RECALL 24V254 / 2024-214 REMEDY INSTRUCTIONS

Make(s): AURORA & CATALINA
Model(s): MANY, SEE BELOW
Model Year(s): 2024

Concern:
The charge line may not have over-current protection.

FIGURE 1

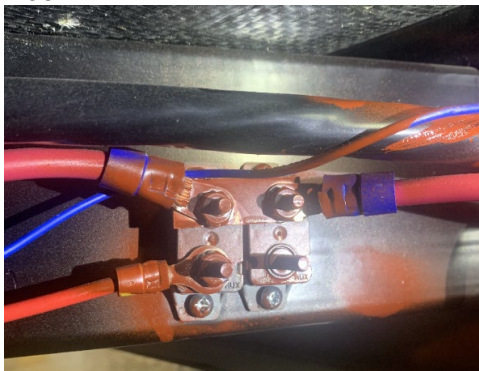
STEP 2: IF THE 6 AWG. WIRES ARE CONNECTED AS SHOWN IN FIGURE 1, MOVE ON TO THE REMEDY;

STEP 1: LOCATE THE 6 AWG. WIRE ON THE REAR POST OF THE MINI-BREAKER. LOOSEN THE NUT AND REMOVE THE WIRE/EYELET;

STEP 3: REMOVE THE NUT FROM THE LOWER POST ON THE REAR MINI-BREAKER;

- REMOVE THE SMALLER WIRE/EYELET FROM THE POST;
- INSTALL THE 6 AWG. WIRE/EYELET ONTO THE POST;
- RE-INSTALL THE SMALLER WIRE/EYELET ONTO THE POST. ROTATE THE SMALLER WIRE WHERE THE EYELET CRIMPS DO NOT OVERLAP. IF THEY OVERLAP, THEY MAY BECOME LOOSE.
- INSTALL THE NUT AND TIGHTEN, CLAMPING THE TWO WIRE/EYELETS TOGETHER, ENSURING PROPER SECUREMENT;
- THE REMEDY SHOULD NOW MATCH FIGURE 2;
